ADDENDUM NO. 01

Oak Hill United School Corporation – Multi-School MEP Improvements
405 South Washington St, Swayzee, IN 46986
7760 Delphi Pike, Converse, IN 46919
600 Walnut St, Converse, IN 46919

Addendum One (AD.01) to the drawings and specifications prepared by Gibraltar Design for **Mechanical Improvements Across Three Schools** for Oak Hill United School Corporation Converse, Indiana.

© GIBRALTAR DESIGN
B
SHEET
EP102

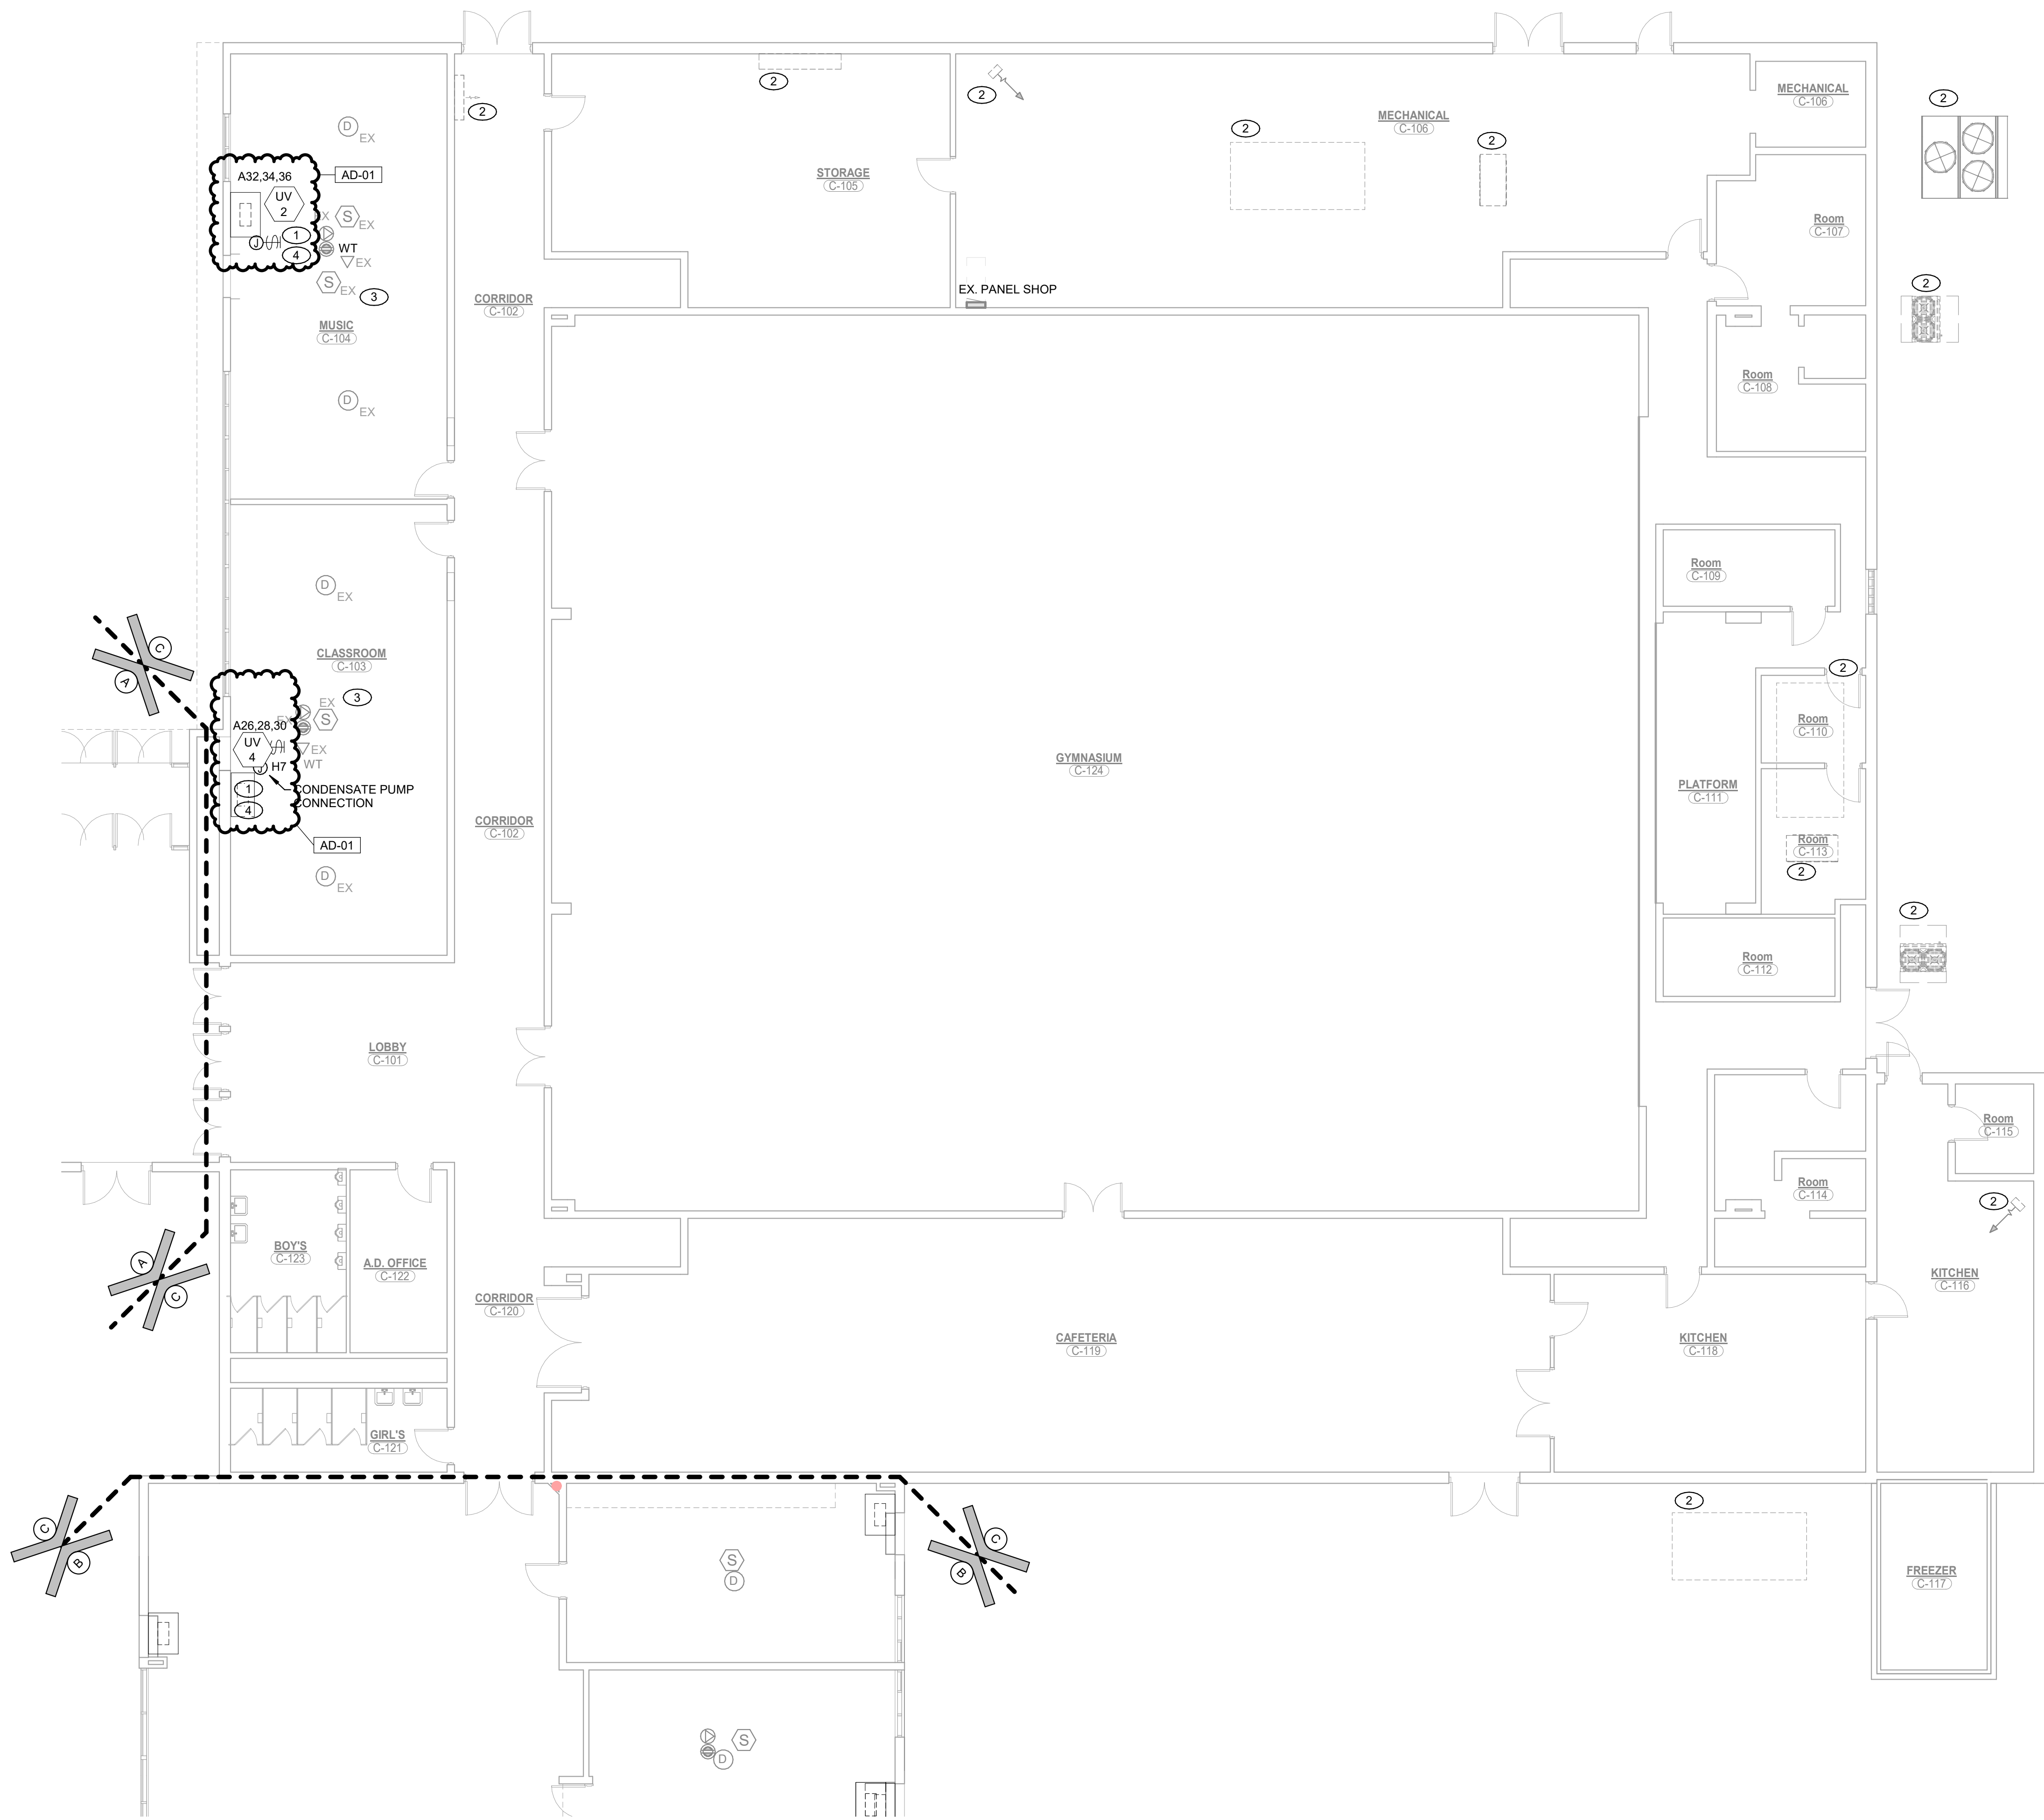
36. Sheet EP102

- A. Refer to revised, full-size drawing, included in this Addendum, for revisions.
 1. Added circuit tags to clarify what is already shown in the mechanical connection schedule.
 2. Removed speaker.
 3. Added general note #2.

© GIBRALTAR
DESIGN
SHEET
C
EP103

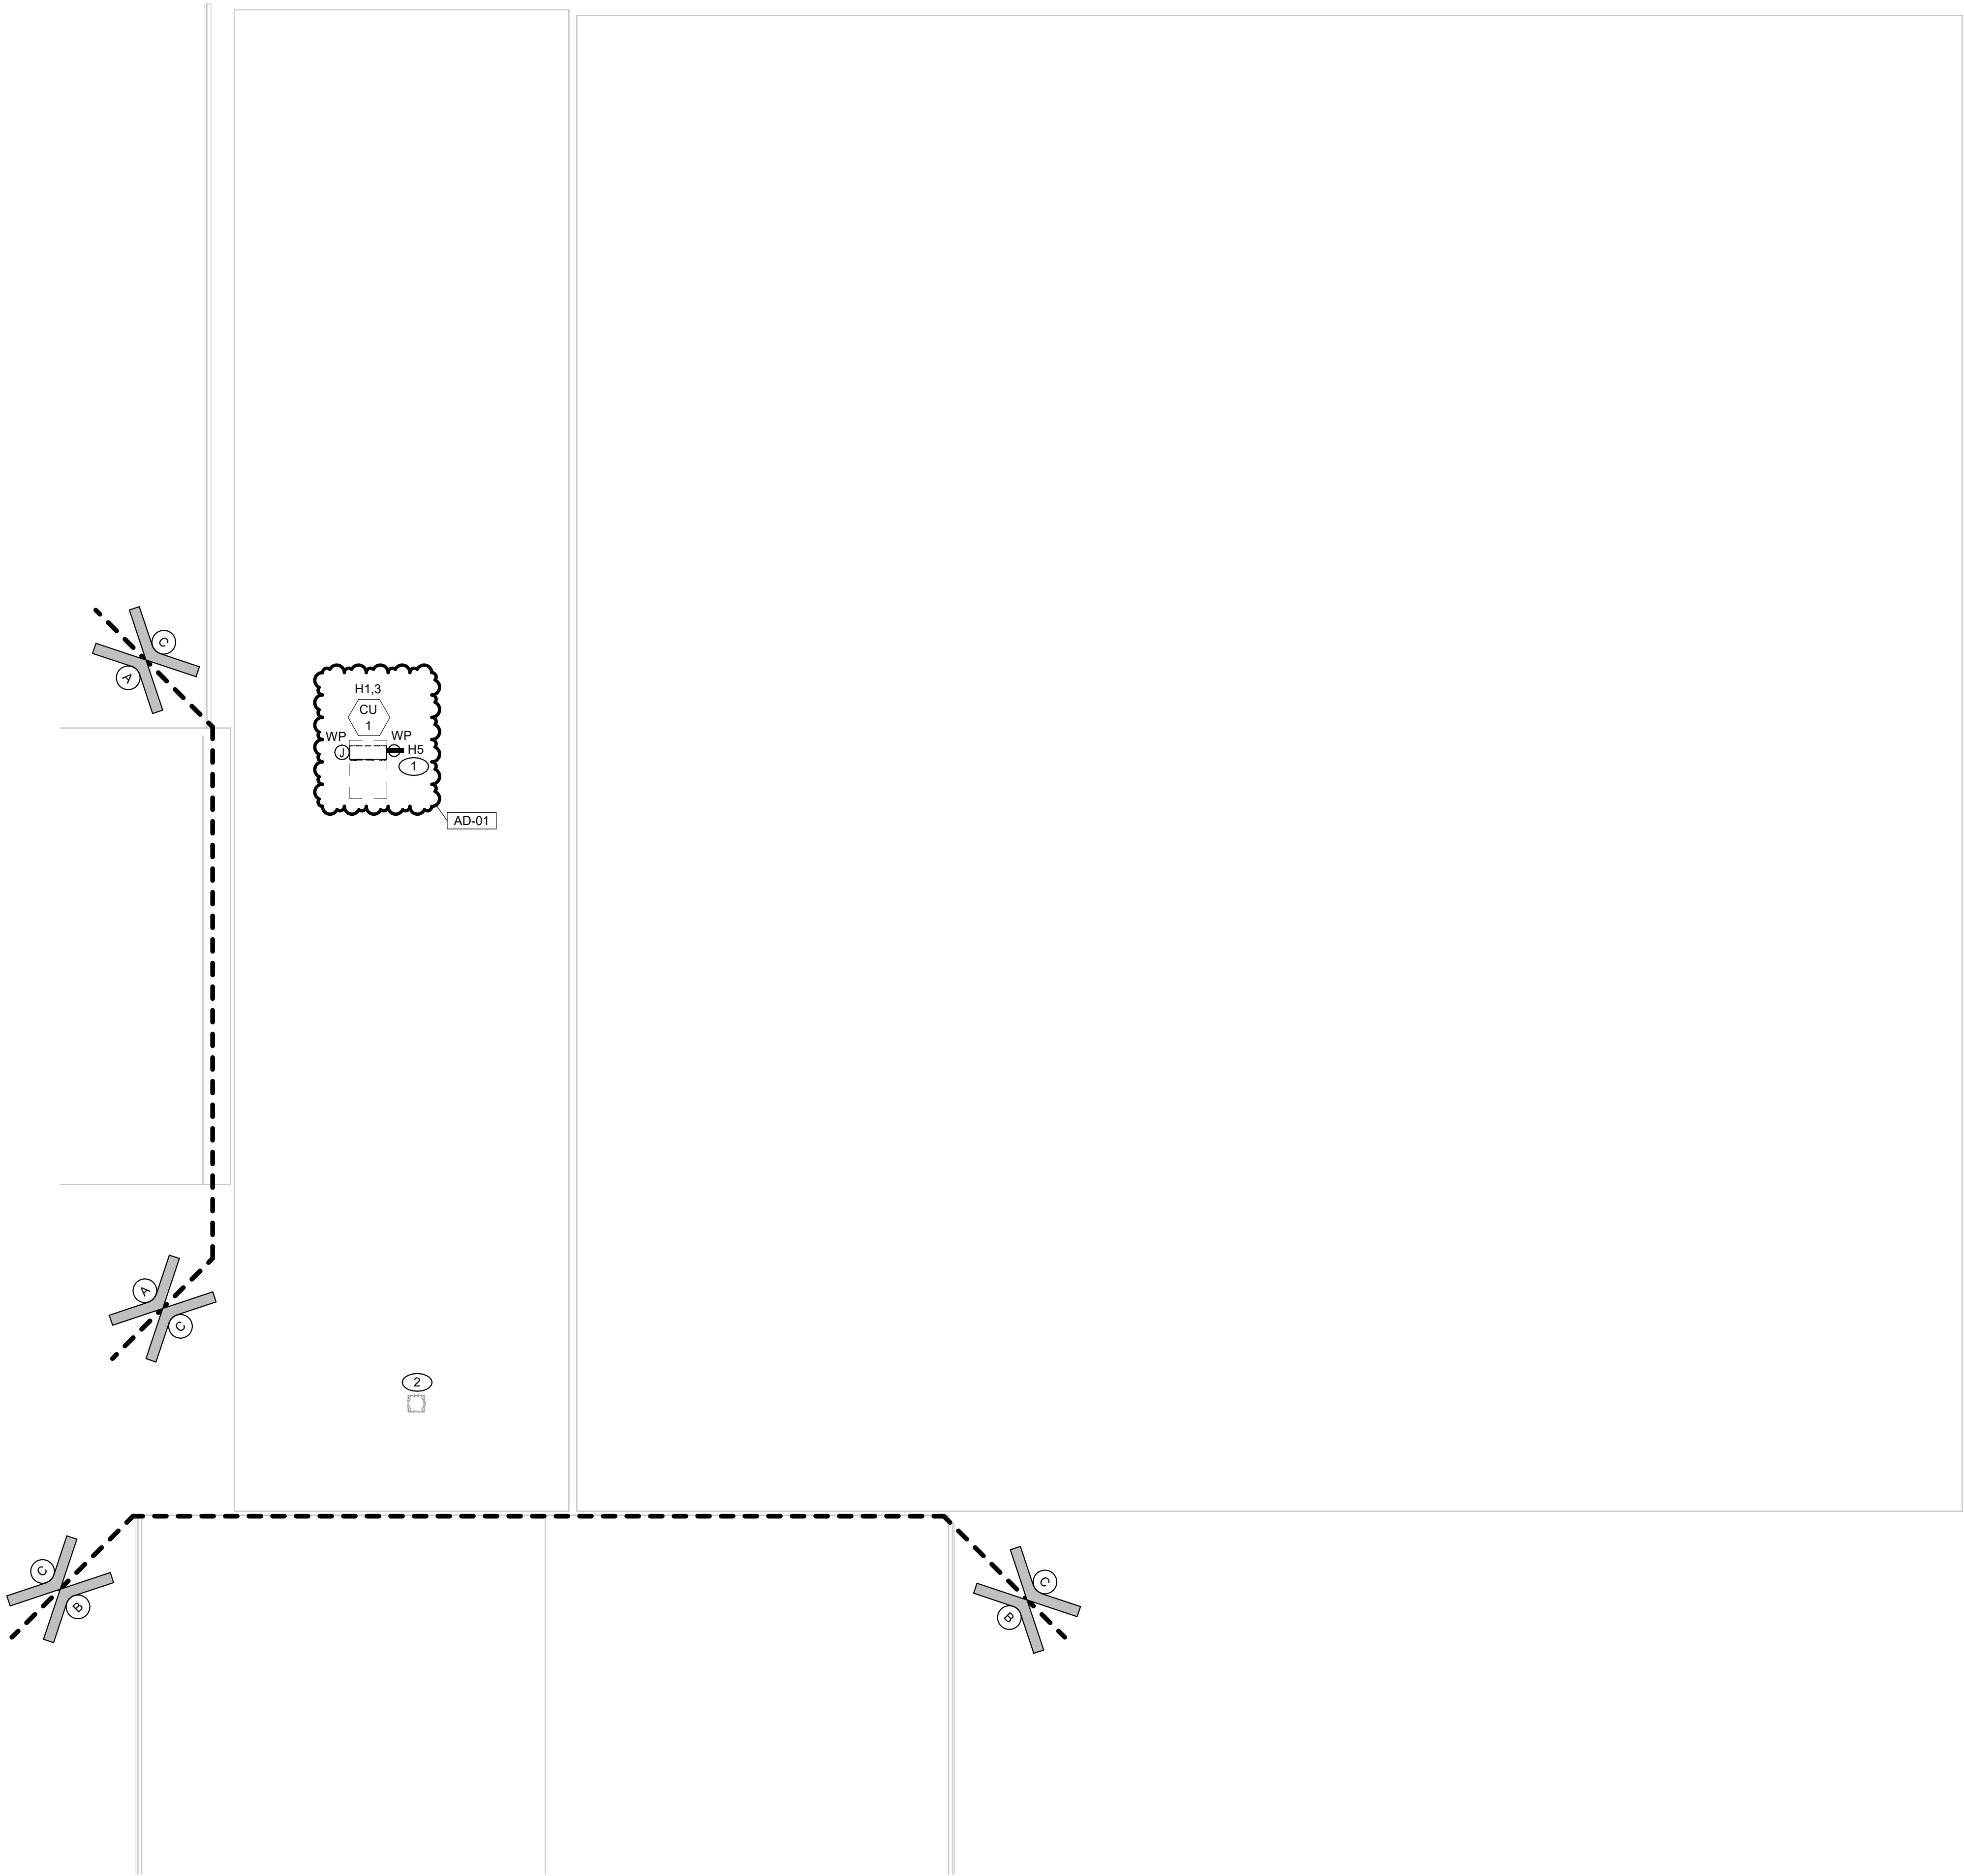
37. Sheet EP103

- A. Refer to revised, full-size drawing, included in this Addendum, for revisions.
 1. Added circuit tags to clarify what is already shown in the mechanical connection schedule.
 2. Revised general note #2.

ED101

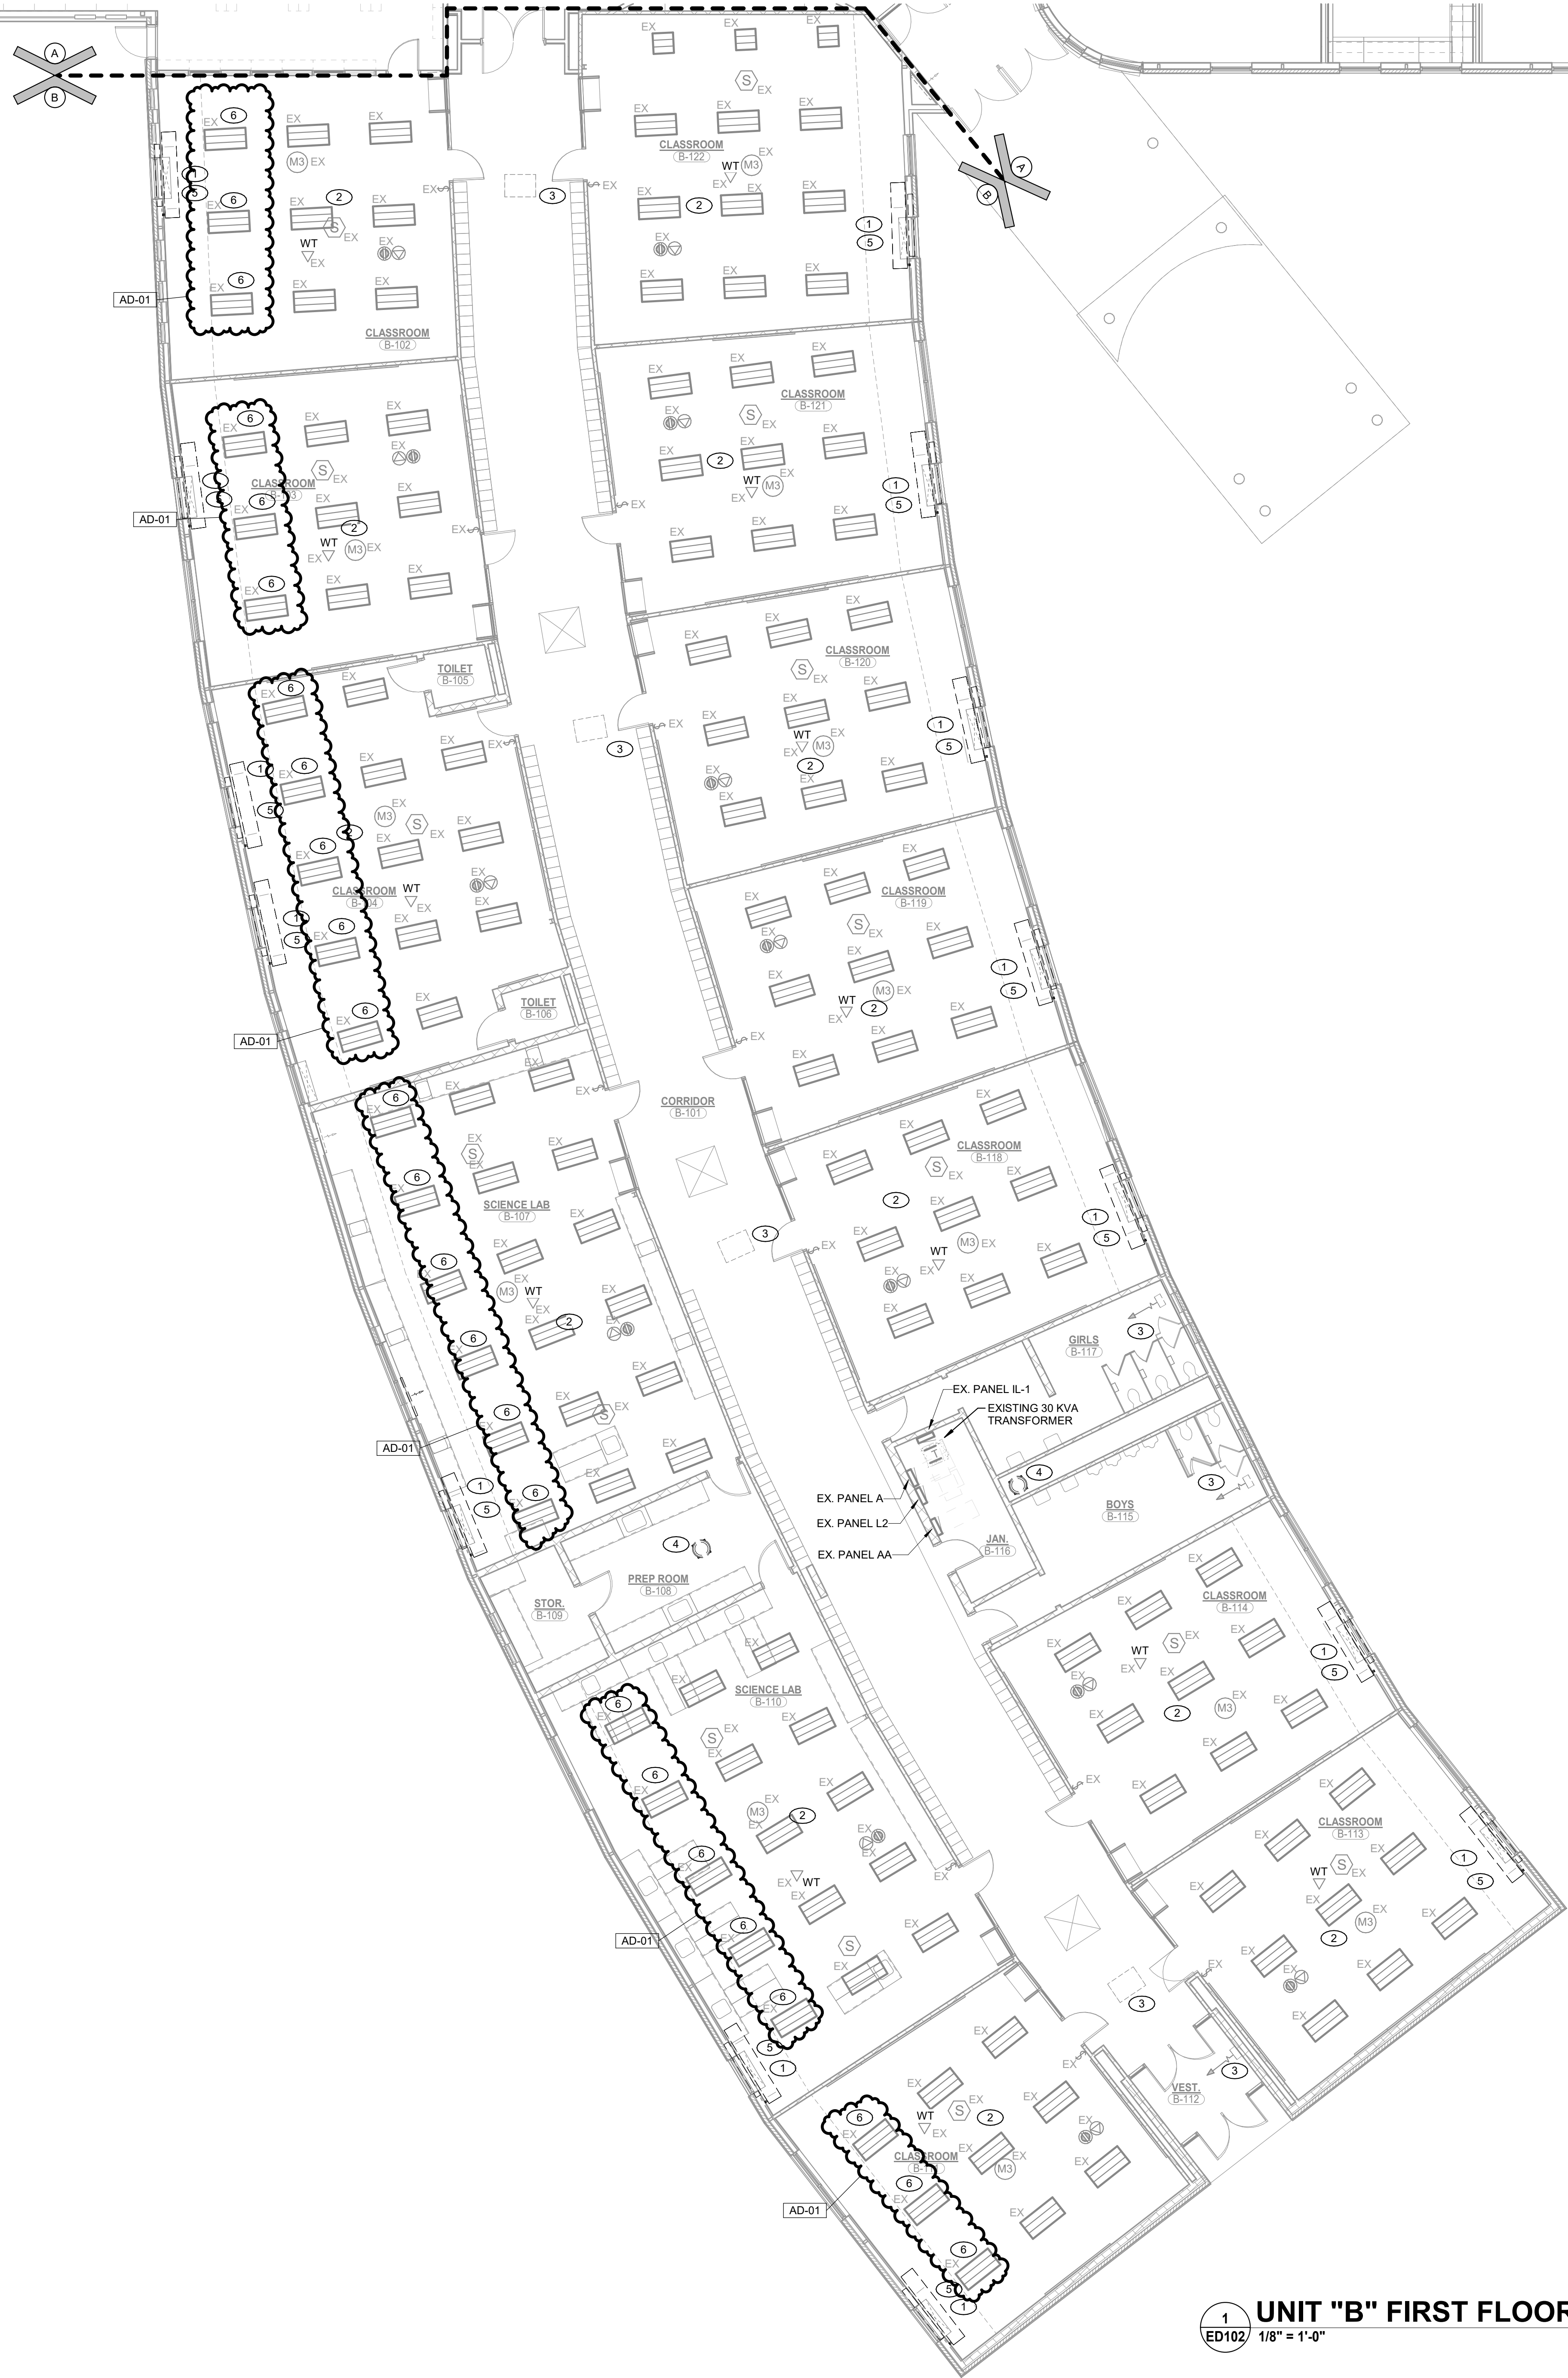
44. Sheet ED101

- A. Refer to revised, full-size drawing, included in this Addendum, for revisions.
 - 1. Added general note #2.
 - 2. Revised lighting layout.
 - 3. Revised lighting phasing.
